## PCI-SIG ENGINEERING CHANGE NOTICE

<b>TITLE:</b>	Readiness Notifications (RN)
<b>DATE:</b>	Last change: 27 August 2013 PWG approved for final release: 29 Aug 2013
<b>AFFECTED DOCUMENT:</b>	PCI Express Base Spec. Rev. 3.0, PCI Local Bus Specification Revision 3.0, PCI Bus Power Management Interface Specification Revision 1.2, Single Root I/O Virtualization and Sharing Revision 1.1, PCI Code and ID Assignment Specification Version 1.3
<b>SPONSOR:</b>	Dell, HP, IDT, Intel, NVIDIA, AMD

**Figure 2-x2: FRS Message**

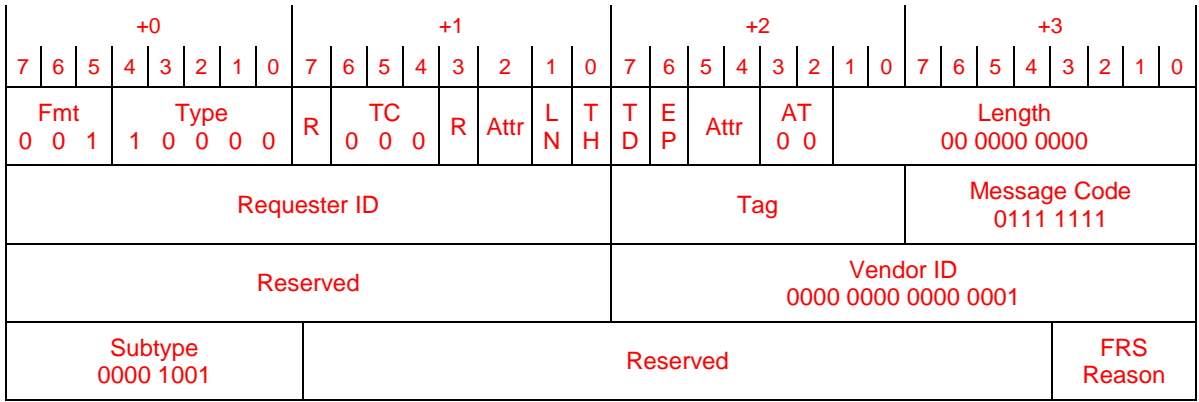
- Table 2-x2 and Figure 2-x2 illustrate and define the FRS Message.
- The TLP Type must be Msg.
- 20  The TC[2:0] field must be 000b.
- The Attr[2:0] field is Reserved.
- The Tag field is Reserved.
- The FRS Reason[3:0] field indicates why the FRS Message was generated:

- **0001b: DRS Message Received** - The Downstream Port indicated by the Message Requester ID received a DRS Message and has the DRS Signaling Control field in the Link Control register set to DRS to FRS Signaling Enabled

- **0010b: D3<sub>hot</sub> to D0 Transition Completed** - A D3<sub>hot</sub> to D0 transition has completed, and the Function indicated by the Message Requester ID is now Configuration-Ready and has returned to the D0<sub>uninitialized</sub> or D0<sub>active</sub> state depending on the setting of the No\_Soft\_Reset bit (see *PCI Bus Power Management Interface Specification* Section 3.2.4 and Section 5.4.1)

- **0011b: FLR Completed** - An FLR has completed, and the Function indicated by the Message Requester ID is now Configuration-Ready
- **1000b: VF Enabled** – The Message Requester ID indicates a PF - All VFs associated with that PF are now Configuration-Ready

- **1001b: VF Disabled** – The Message Requester ID indicates a PF - All VFs associated with that PF have been disabled and the SR-IOV data structures in that PF may now be accessed.

The Message Routing field must be set to 000b – Routed to Root Complex

Figure 7-17: Link Control Register

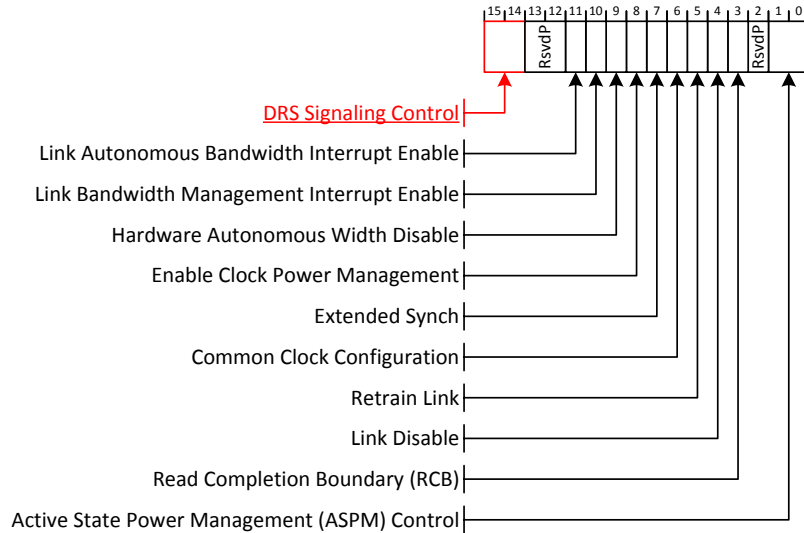
Bit Location	Register Description	Attributes
...	...	...
<u>15:14</u>	<p><u>DRS Signaling Control – Indicates the mechanism used to report reception of a DRS Message. Must be implemented for Downstream Ports with the DRS Supported bit Set in the Link Capabilities 2 register. Encodings are:</u></p> <p><u>00b DRS not Reported: If DRS Supported is Set, receiving a DRS Message will set DRS Message Received in the Link Status 2 register but will otherwise have no effect</u></p> <p><u>01b DRS Interrupt Enabled: If the DRS Message Received bit in the Link Status 2 register transitions from 0 to 1, and either MSI or MSI-X is enabled, an MSI or MSI-X interrupt is generated using the vector in Interrupt Message Number (section 7.8.2)</u></p> <p><u>10b DRS to FRS Signaling Enabled: If the DRS Message Received bit in the Link Status 2 register transitions from 0 to 1, the Port must send an FRS Message Upstream with the FRS Reason field set to DRS Message Received</u></p> <p><u>Behavior is undefined if this field is set to 10b and the FRS Supported bit in the Device Capabilities 2 register is Clear.</u></p> <p><u>Behavior is undefined if this field is set to 11b.</u></p> <p><u>Downstream Ports with the DRS Supported bit Clear in the Link Capabilities 2 register must hardwire this field to 00b.</u></p> <p><u>This field is Reserved for Upstream Ports.</u></p> <p><u>Default value of this field is 00b.</u></p>	<u>RW/RsvdP</u>

Figure 7-25: Device Capabilities 2 Register

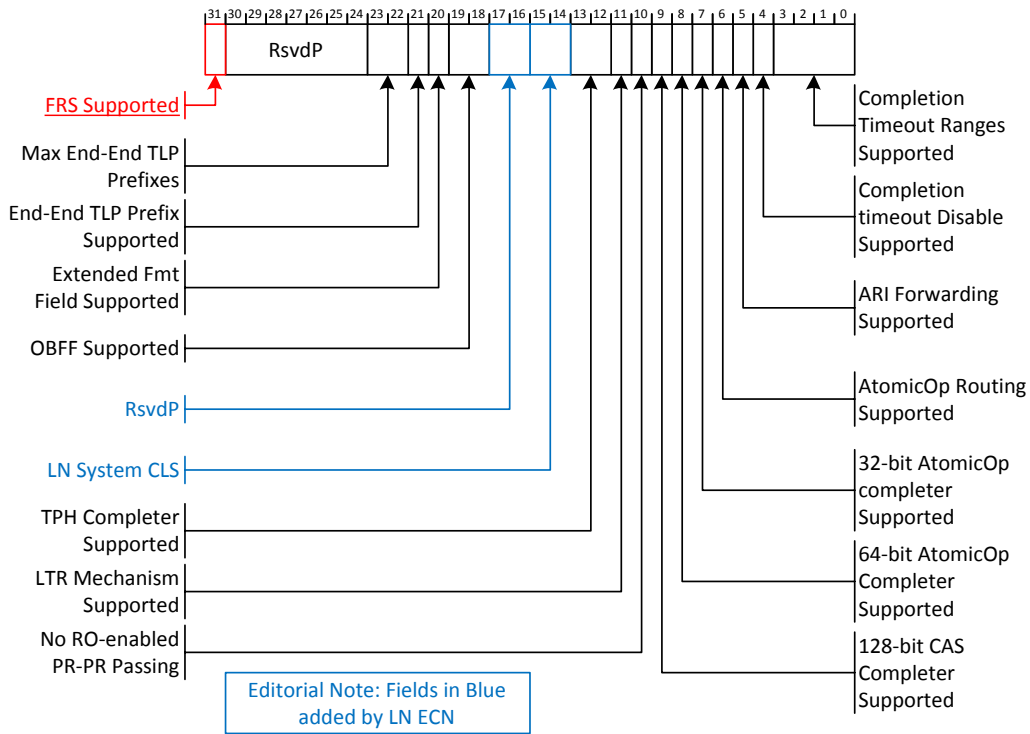
Bit Location	Register Description	Attributes
...	...	...
<u>31</u>	<p><u><b>FRS Supported</b></u> – When Set, indicates support for the optional <u>Function Readiness Status (FRS) capability.</u></p> <p><u>Must be Set for all Functions that support generation or receipt capabilities of FRS Messages.</u></p> <p><u>Must not be Set by Switch Functions that do not generate FRS Messages on their own behalf.</u></p>	<u>HwInit</u>

Figure 7-27: Link Capabilities 2 Register

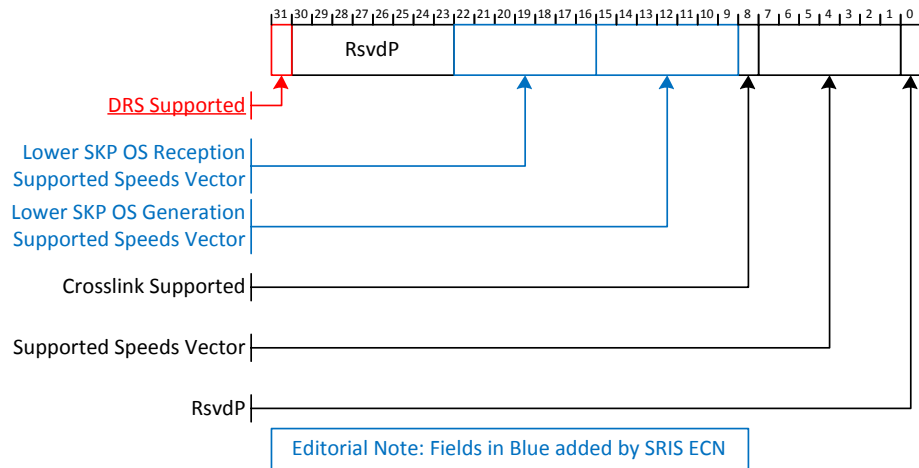
Bit Location	Register Description	Attributes
...	...	...
<u>31</u>	<p><u>DRS Supported – When Set, indicates support for the optional Device Readiness Status (DRS) capability.</u></p> <p><u>Must be Set in Downstream Ports that support DRS.</u></p> <p><u>Must be Set in Downstream Ports that support FRS.</u></p> <p><u>For Upstream Ports that support DRS, it is strongly recommended that this bit be Set in Function 0. For all other Functions associated with an Upstream Port, this bit must be Clear.<sup>1</sup></u></p> <p><u>Must be Clear in Functions that are not associated with a Port.</u></p> <p><u>RsvdP in all other Functions.</u></p>	<u>HwInit/RsvdP</u>

Figure 7-29: Link Status 2 Register

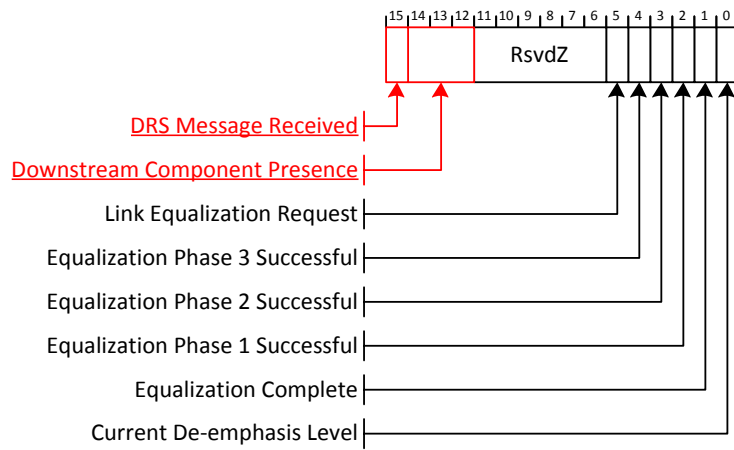
Bit Location	Register Description	Attributes
...	...	...
<u>14:12</u>	<p><b><u>Downstream Component Presence</u></b> – This field indicates the presence and DRS status for the Downstream Component, if any, connected to the Link; defined values are:</p> <p><u>000b</u> Link Down – Presence Not Determined</p> <p><u>001b</u> Link Down – Component Not Present indicates the Downstream Port (DP) has determined that a Downstream Component is not present</p> <p><u>010b</u> Link Down – Component Present indicates the DP has determined that a Downstream Component is present, but the Data Link Layer is not active</p> <p><u>011b</u> Reserved</p> <p><u>100b</u> Link Up – Component Present indicates the DP has determined that a Downstream Component is present, but no DRS Message has been received since the Data Link Layer became active</p> <p><u>101b</u> Link Up – Component Present and DRS Received indicates the DP has received a DRS Message since the Data Link Layer became active</p> <p><u>110b</u> Reserved</p> <p><u>111b</u> Reserved</p> <p><u>Component Presence state must be determined by the logical “OR” of the Physical Layer in-band presence detect mechanism and, if present, any out-of-band presence detect mechanism implemented for the Link. If no out-of-band presence detect mechanism is implemented, then Component Presence state must be determined solely by the Physical Layer in-band presence detect mechanism.</u></p> <p><u>This field must be implemented in any Downstream Port where the DRS Supported bit is Set in the Link Capabilities 2 register.</u></p> <p><u>This field is RsvdZ for all other Functions.</u></p> <p><u>Default value of this field is 000b.</u></p>	<u>RO/RsvdZ</u>

<u>15</u>	<p><b><u>DRS Message Received</u></b> – This bit must be Set whenever the Port receives a DRS Message.</p> <p><u>This bit must be Cleared in DL Down.</u></p> <p><u>This bit must be implemented in any Downstream Port where the DRS Supported bit is Set in the Link Capabilities 2 register.</u></p> <p><u>This bit is RsvdZ for all other Functions.</u></p> <p><u>Default value of this bit is 0b.</u></p>	<u>RW1C / RsvdZ</u>

**Figure 7-x1 FRS Extended Capability**

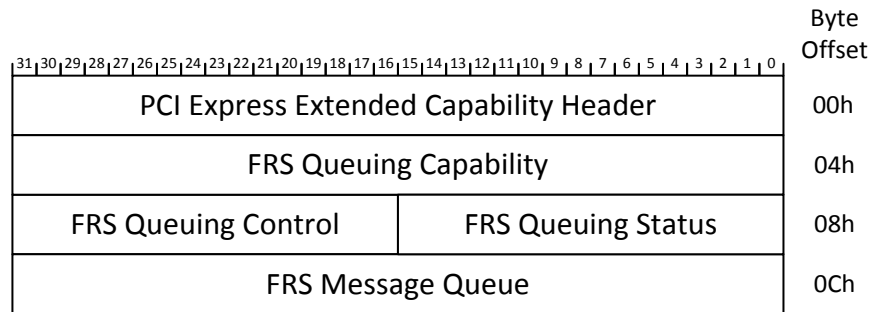
- 5 The Function Readiness Status (FRS) Queuing Extended Capability is required for Root Ports and Root Complex Event Collectors that support the optional normative FRS Queuing capability. See Section 6.x. This extended capability is only permitted in Root Ports and Root Complex Event Collectors.

If this capability is present in a Function, that Function must also implement either MSI, MSI-X, or both.

**Figure 7-x6 FRS Message Queue Register**

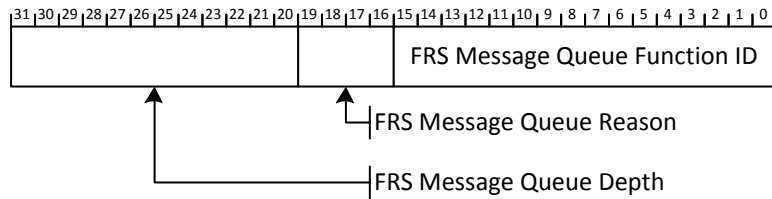
The FRS Message Queue Register contains fields from the oldest FRS message in the queue. It also indicates the number of FRS messages in the queue.

A write of any value that includes byte 0 to this register removes the oldest FRS Message from the queue and updates these fields. A write to this register when the queue is empty has no effect.

<b>Bit Location</b>	<b>Register Description</b>	<b>Attributes</b>
<u>15:0</u>	<b>FRS Message Queue Function ID</b> – Recorded from the Requester ID of the oldest FRS Message received or generated by this Root Port or Root Complex Event Collector and still in the queue. <u>Undefined if FRS Message Queue Depth is 000h.</u>	<u>RO</u>
<u>19:16</u>	<b>FRS Message Queue Reason</b> – Recorded from the FRS Reason of the oldest FRS Message received or generated by this Root Port or Root Complex Event Collector and still in the queue. <u>Undefined if FRS Message Queue Depth is 000h.</u>	<u>RO</u>
<u>31:20</u>	<b>FRS Message Queue Depth</b> – indicates the current number of FRS Messages in the queue. <u>The value of 000h indicates an empty queue.</u> <u>Default value of this field is 000h.</u>	<u>RO</u>

**Figure 7-y1: Readiness Time Reporting Extended Capability**

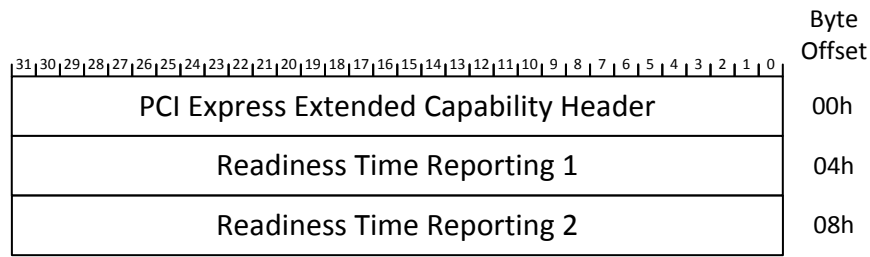
5 The Readiness Time Reporting Extended Capability provides an optional mechanism for describing the time required for a Device or Function to become Configuration-Ready. In the indicated situations, software is permitted to issue Requests to the Device or Function after waiting for the time advertised in this capability and need not wait for the (longer) times required elsewhere.

- 5 The time values reported are determined by implementation-specific mechanisms. A valid bit is defined in this capability to permit a device to defer reporting time values, for example to allow hardware initialization through driver-based mechanisms. If the Valid bit remains Clear and 1 minute has elapsed after device driver(s) have started, software is permitted to assume that no values will be reported.
- 10 Registers and fields in the Readiness Time Reporting Extended Capability are shown in Figure 7-y1. Time values are encoded in floating point as shown in Figure 7-y2. The actual time value is  $Value \times Multiplier[Scale]$ . For example, the value A1Eh represents about 1 second (actually 1.006 sec) and the value 40Ah represents about 10 ms (actually 10.240 ms).

Figure 6-3: Status Register Layout

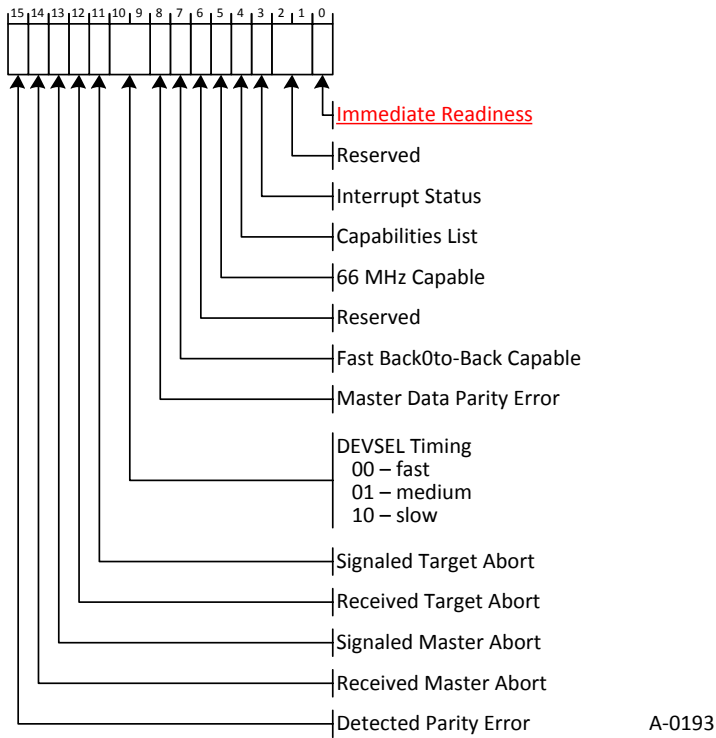
Bit Location	Description
<u>0</u>	<p><b>Immediate Readiness</b> – This optional read-only bit, when Set, indicates the Function is guaranteed to be ready to successfully complete valid configuration accesses at any time following any reset that the host is capable of issuing Configuration Requests to this Function.</p> <p>When this bit is set, for accesses to this Function, software is exempt from all requirements to delay configuration accesses following any type of reset, including but not limited to the timing requirements defined in Section 4.3.2.</p> <p>How this guarantee is established is beyond the scope of this document.</p> <p>It is permitted that system software/firmware provide mechanisms that supersede the indication provided by this bit, however such software/firmware mechanisms are outside the scope of this specification.</p>
...	...
